# UNITED STATES PATENT AND TRADEMARK OFFICE

APPLICATION NO.	FILING DATE	FIRST NAMED INVENTOR	ATTORNEY DOCKET NO.	CONFIRMATION NO.
10/624,559	07/23/2003	Masaharu Nishikawa	50195-375	6633

**Office Action Summary**

## **DETAILED ACTION**

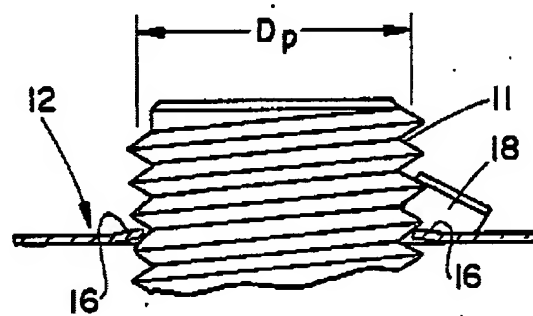
4. Claims 1-2 and 7 are rejected under 35 U.S.C. 102(b) as being anticipated by Fisher USP 4911594

Re claims 1 and 7: Fisher discloses an attachment clip and structure for attaching a first member, having a hole, to a second member, having a projecting bolt passable through said hole, comprising:

- A clip body 12 with an abutment part capable of attaching a first member to a second member, having a shank hole to accommodate passage of a bolt
- A plurality of engagement claws (spring fingers 18 and 16 are both considered claws, per Fig 4 and col 3 lines 51- col 4 line 41) formed around inner periphery of hole and radially projecting inward (Fig 1) and inclined to the clip body so that

the respective tips depart in an axial direction from clip body, thereby providing claws as a whole a substantially cone-shaped configuration (best seen Fig 3 – the overall shape of all the claws as a whole projects from the flange in a substantially cone shape)

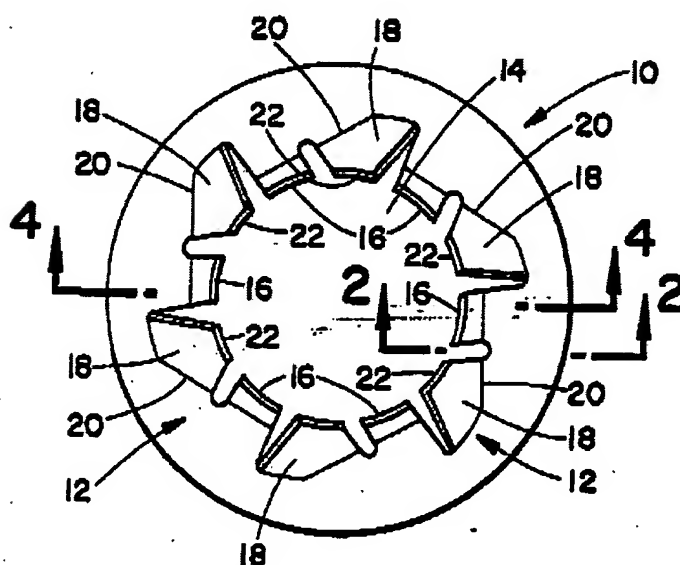
- Wherein engagement claws are capable of engaging bolt shank while urging first member toward second member along bolt axial direction (see Fig 4 below, and

col 3 lines 39- col 4 line 48)

- Wherein engagement claws include at least 2 specific claws adjoining in circumferential direction (Fig 1, adjacent claws 16 and 18, see Fig 1 below)

- Wherein the tips of two specific claws are apart from each other a predetermined distance in height (Fig 4, 18 higher than 16) and the height difference is equal to one or more thread pitches on the bolt shank.

Examiner notes that in addition to the figure above, col 4, lines 20-25 teach that the length of the tip 22 of claw 18 is at least as long or preferably longer than the distance between adjacent thread crests to ensure that the tips or terminal edges are in engagement with at least one thread crest. Thus the tip 22 of claw 18, which has been described as extending along a helical path, is separated from the tip of 16 by a distance equal to at least one or more thread pitches.
